PERMIT
SEWAGE DISPOSAL SYSTEM
HOWARD COUNTY HEALTH DEPARTMENT
BUREAU OF ENVIRONMENTAL HEALTH
410-313-2640

South Carroll Backhoe, Inc IS PERMITTED TO INSTALL x ALTER
ADDRESS 4410 Salem Bottom Road, Westminster, MD 21157 PHONE 410-875-4197
SUBDIVISION Brantwood 2/2 LOT NUMBER 29 ADDRESS 3004 Seneca Chief Trail
PROPERTY OWNER NV Homes PROPERTY OWNER'S ADDRESS 2200 Defense Hwy (21114)
SEPTIC TANK CAPACITY 1250 GALLONS * TOP SEAMED SEPTIC TANK REQUIRED *
PUMP CHAMBER CAPACITY N/A GALLONS
NUMBER OF BEDROOMS 4
SQUARE FEET PER BEDROOM 180
LINEAR FEET OF TRENCH REQUIRED 240

515302-B

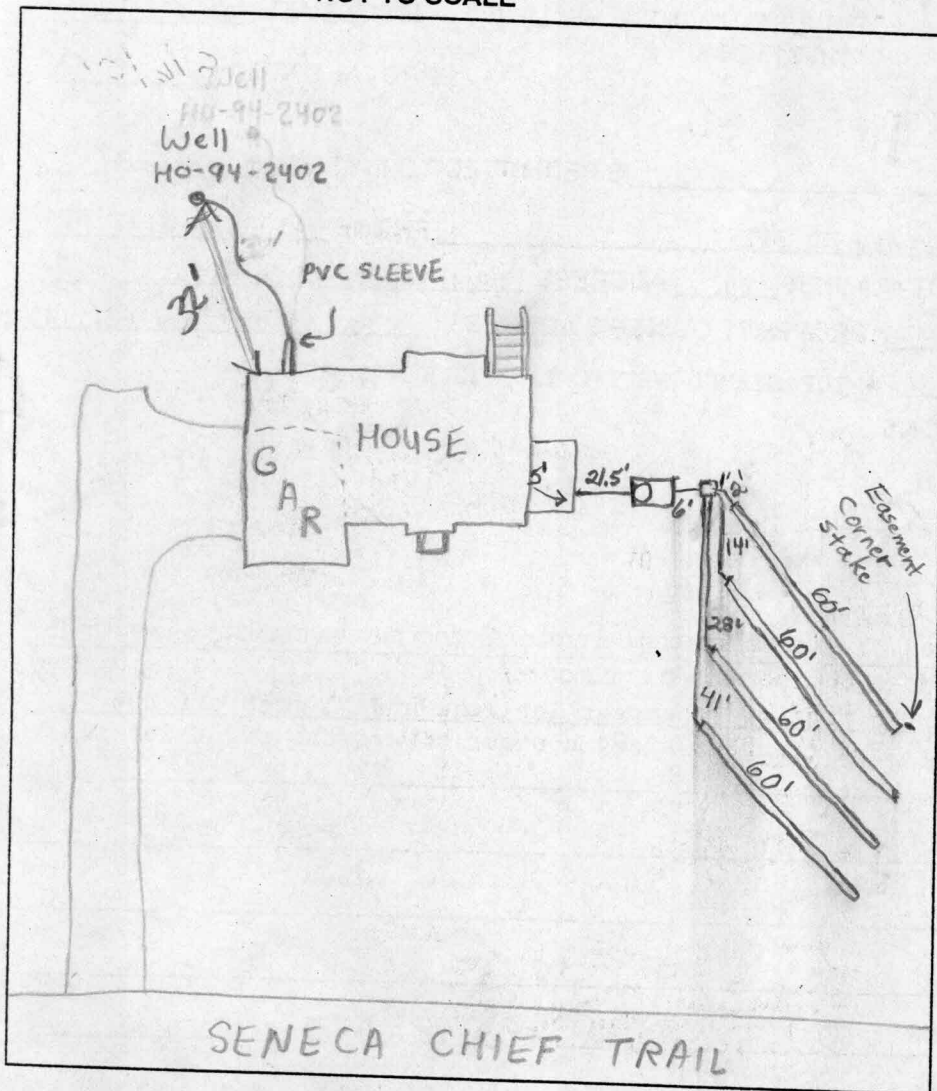
PRE-CONSTRUCTION INSPECTION: T-2401 layout confirmed - SDA staked - OK to start system as specified. DKC

INSPECTION COMMENTS: 8/1/01 - OK TO CONTINUE - (BB) SRK 8/2/01 OK'd AREA for 4x 60' Trenches KG/MR 8/6/01 System satisfactory. O.K. to cover. (BB)
